Appl. No. 10/695,236  
Amdt. dated February 9, 2005  
Reply to Office action of November 10, 2004

**Amendments to the Drawings:**

The attached drawing sheets include changes to FIGs. 1, 2A, 2B, 3, 5, 8, 9, and 12.  
These sheets replace the original drawing sheets.

**FIG. 3.**

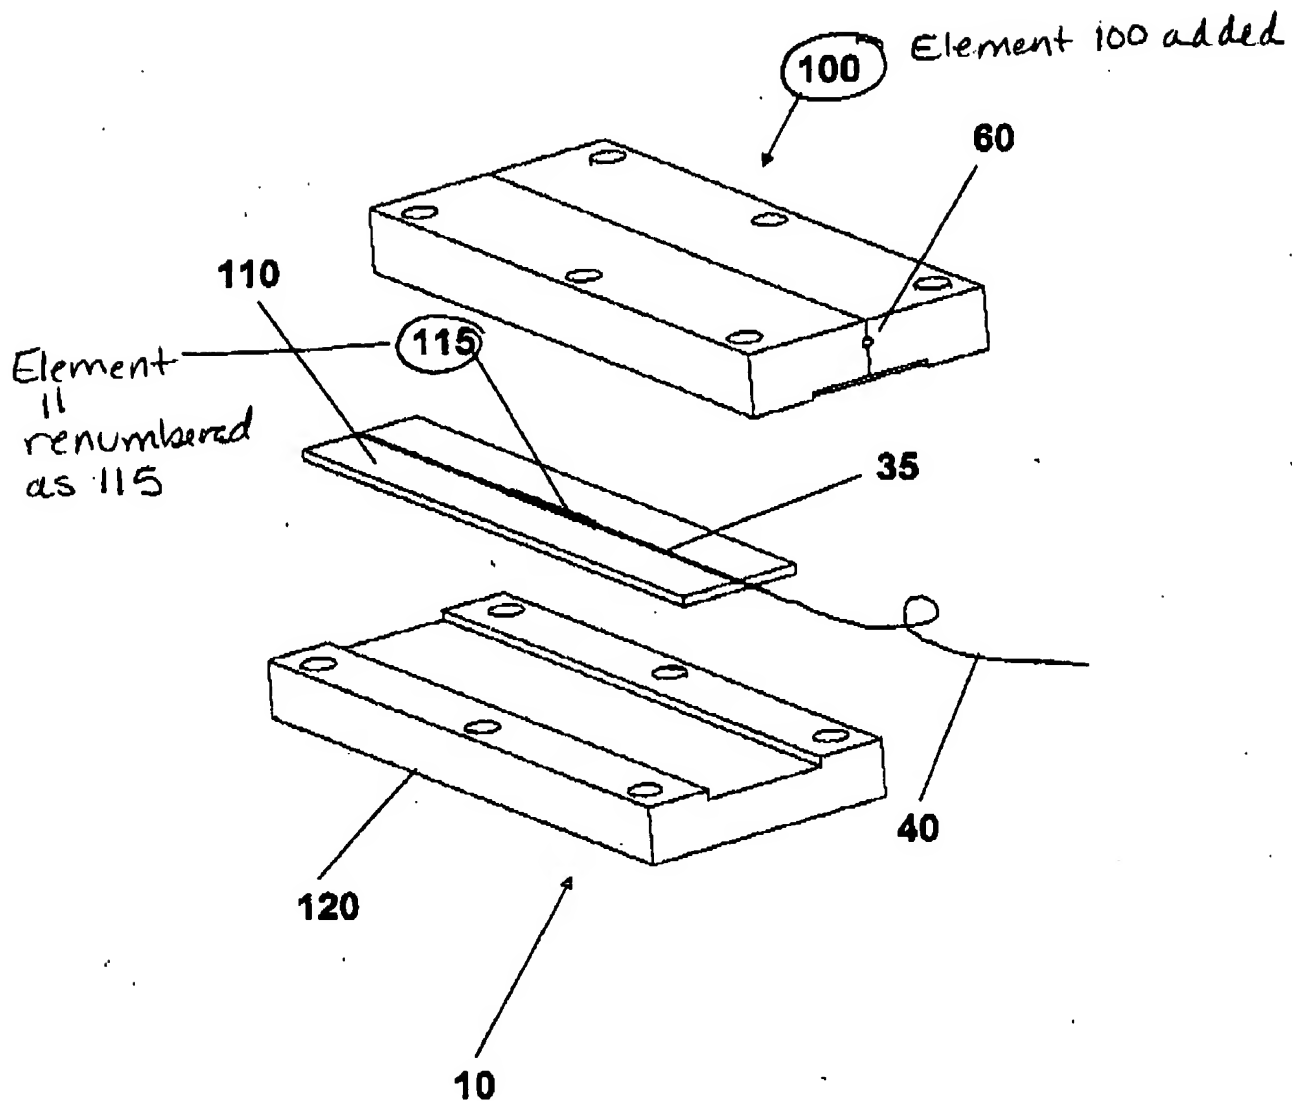
In FIG. 3, previously omitted element 100 has been added. Element 11 has been renumbered as element 115. Support for this amendment is found in paragraph [0040].

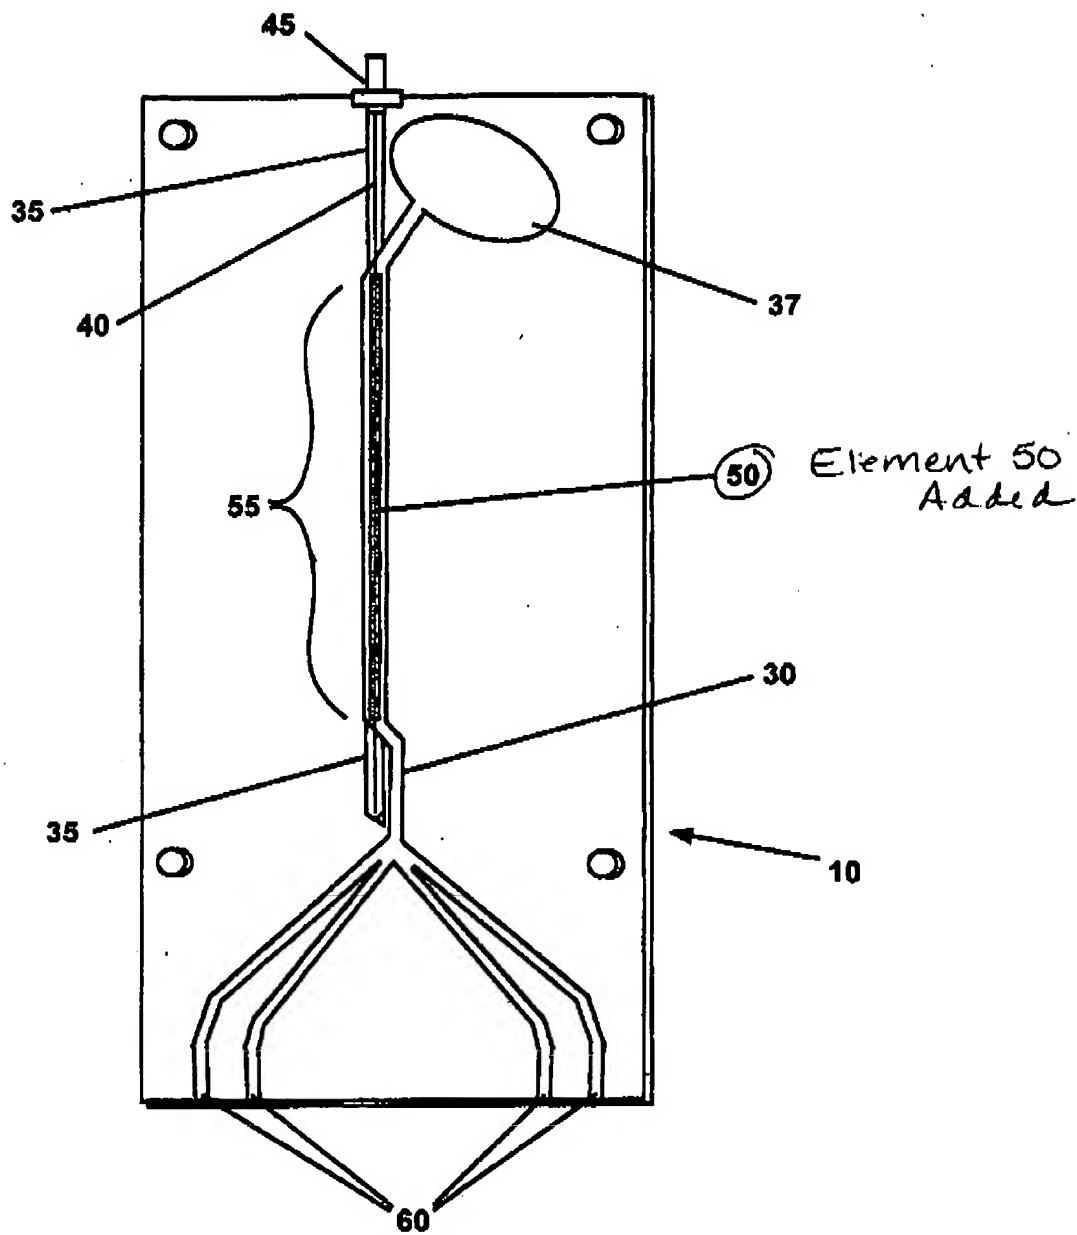
In FIG. 5, previously omitted element 50 has been added. Support for this amendment is found in paragraph [0041].

**FIG. 8.**

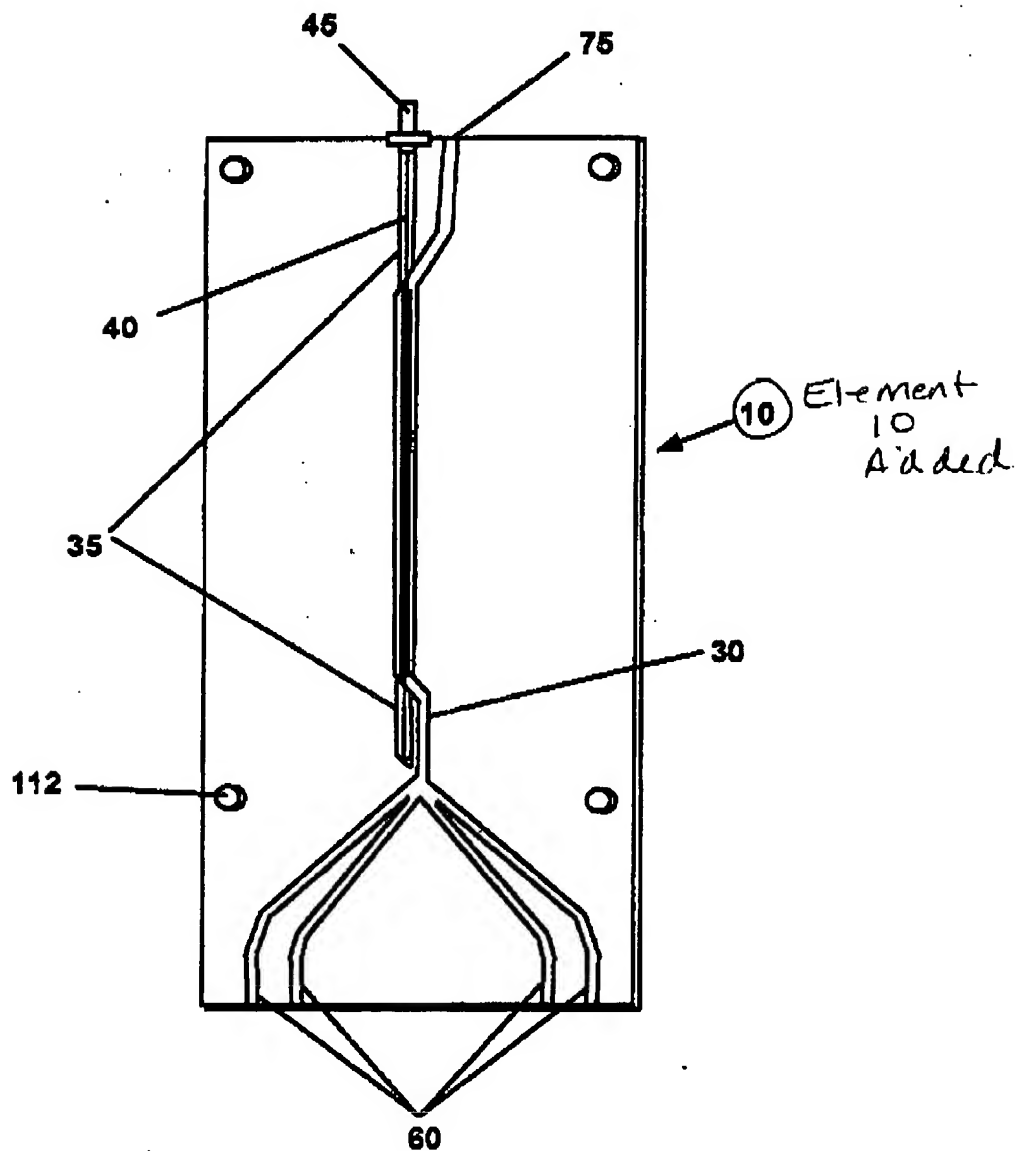
In FIG. 8, previously omitted element 10 has been added. Support for this amendment is found in paragraph [0042].

60  
**FIG. 9.**

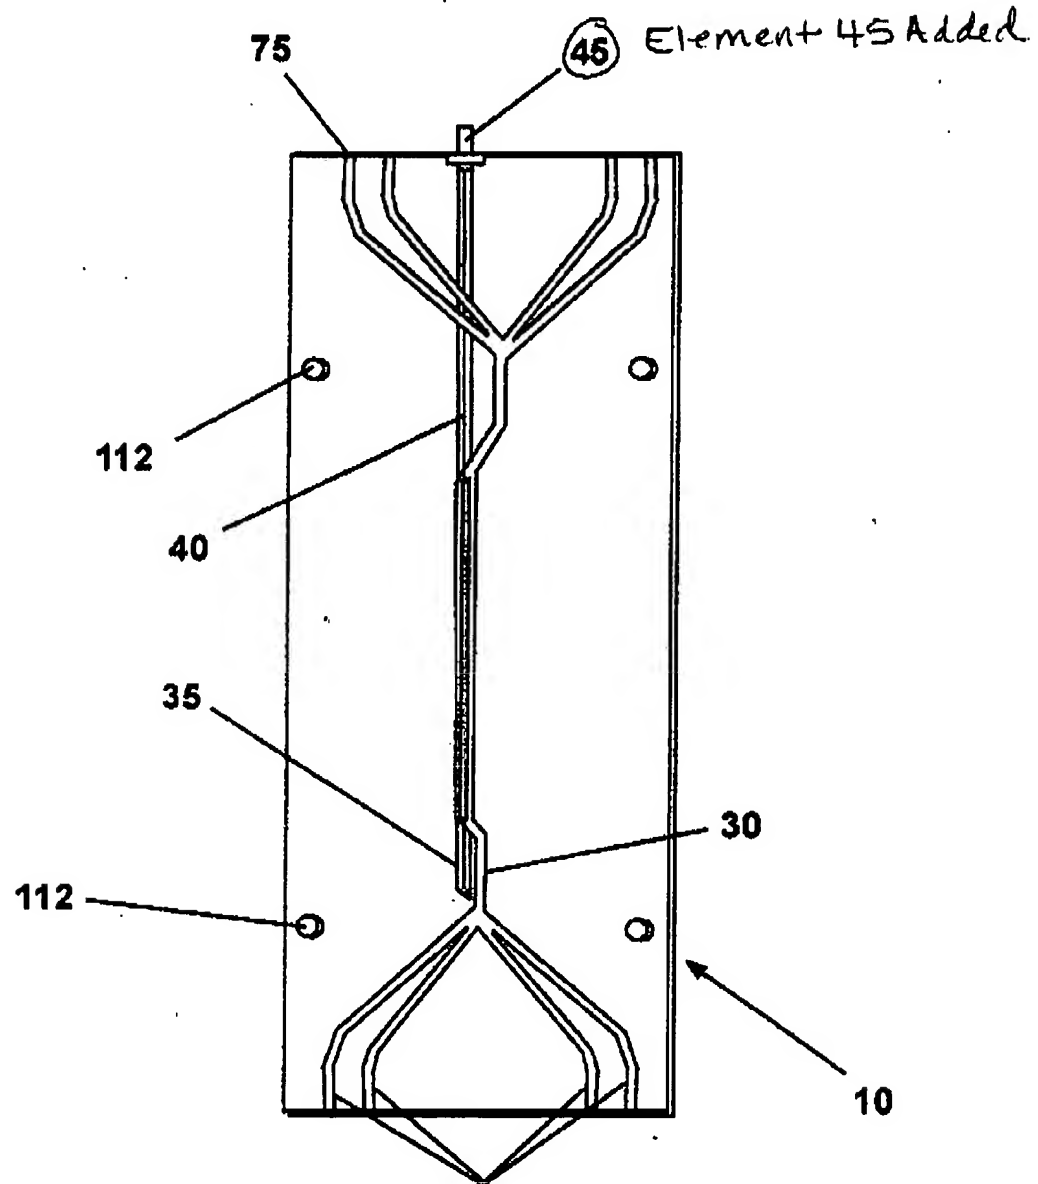
In FIG. 9, previously omitted element 45 has been added. Support for this amendment is found in paragraph [0042].

FIG. 12.

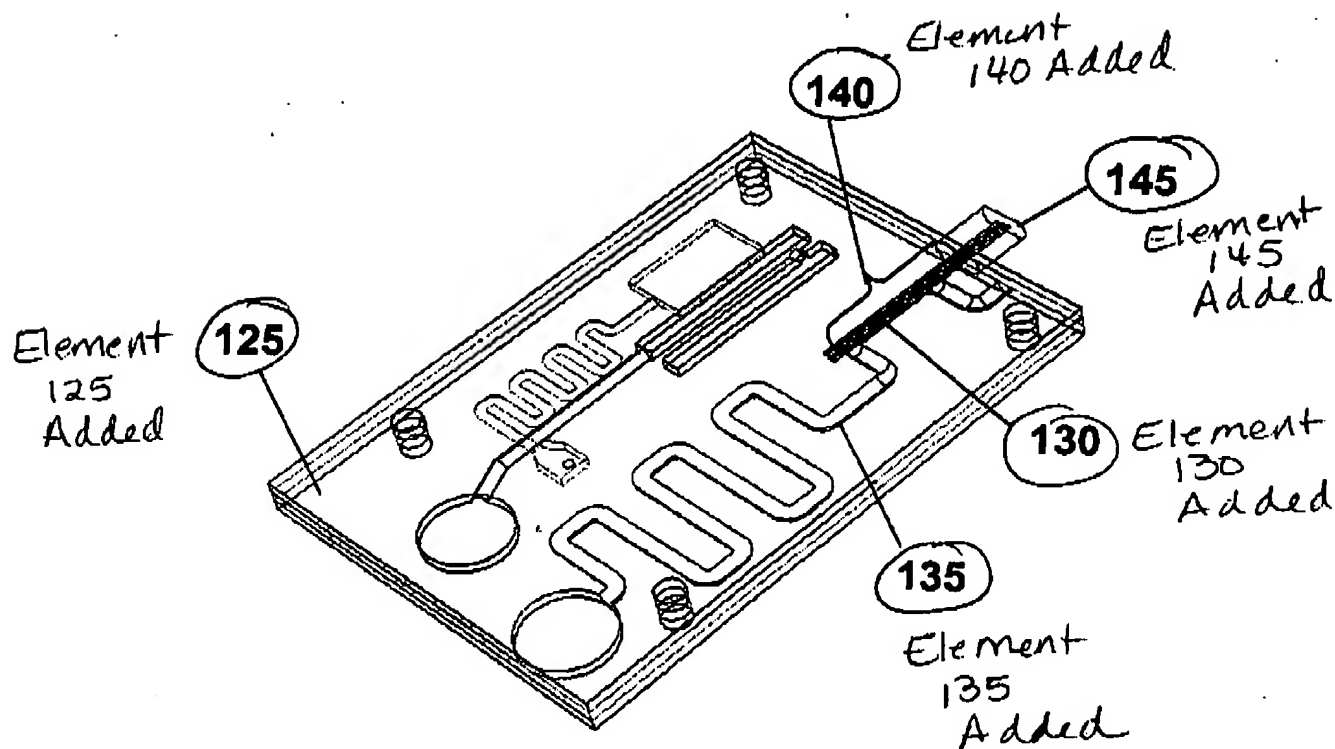
In FIG. 12, previously omitted elements 125, 130, 135, 140 and 145 have been added. Support for this amendment is found in paragraph [0051].
